2007 - 2013 Cadillac CTS-V: GM TechLink: Low Oil Pressure on V8 Engines

Subject: Low Oil Pressure on V8 Engines

Source: GM TechLink

Date: August 10, 2015

Fig. 3

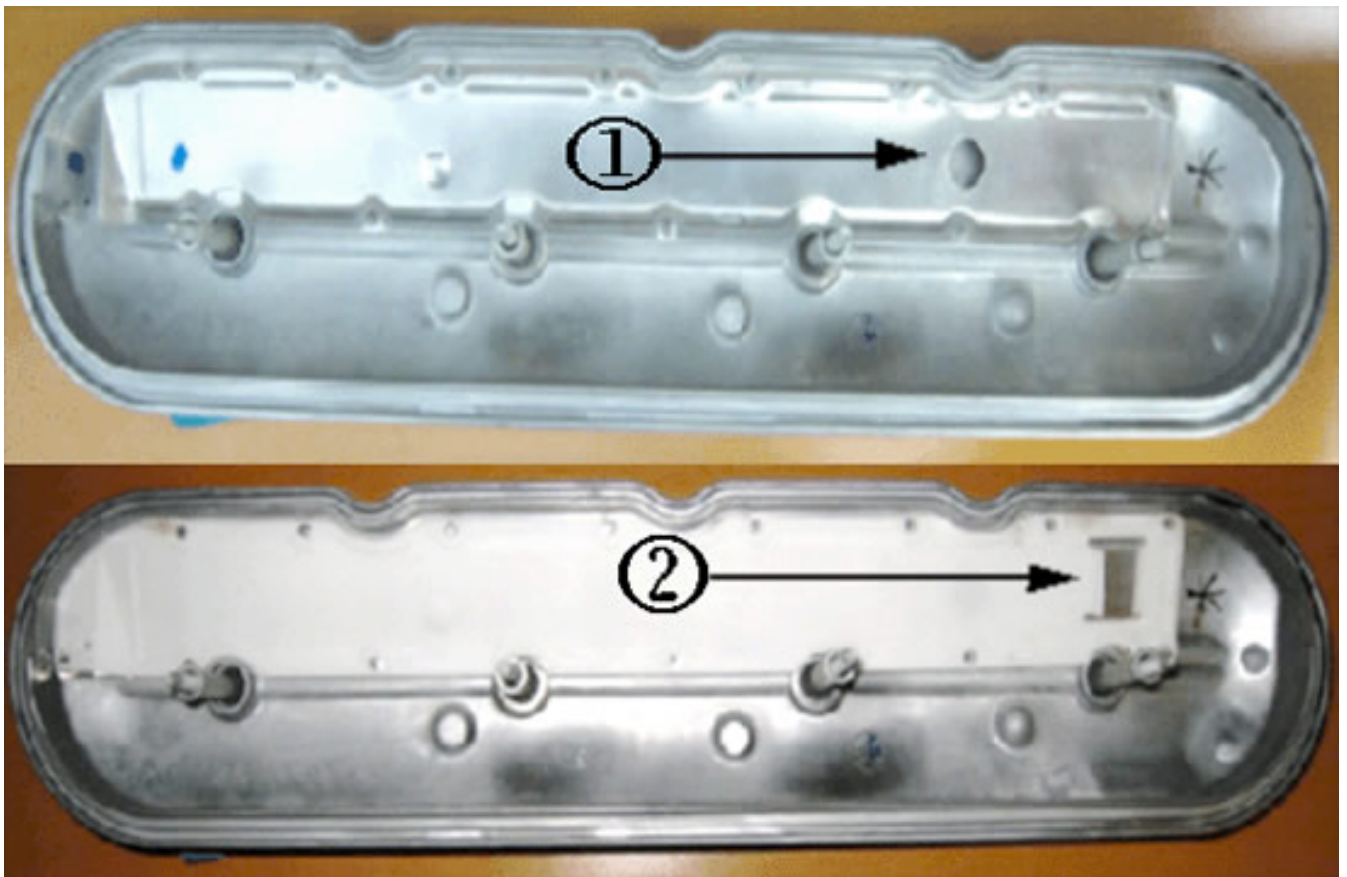
If the engine has been properly repaired and cleaned, inspect the left rocker cover (square baffle) (Fig. 3, #1 – old design; #2 – new design with square baffle) and verify that the baffles can hold water and do not leak. If any leaks

are found, clean and seal the edge of the baffle with RTV, if possible, or replace the valve cover. Thoroughly clean and dry the valve cover before installation and/or resealing.
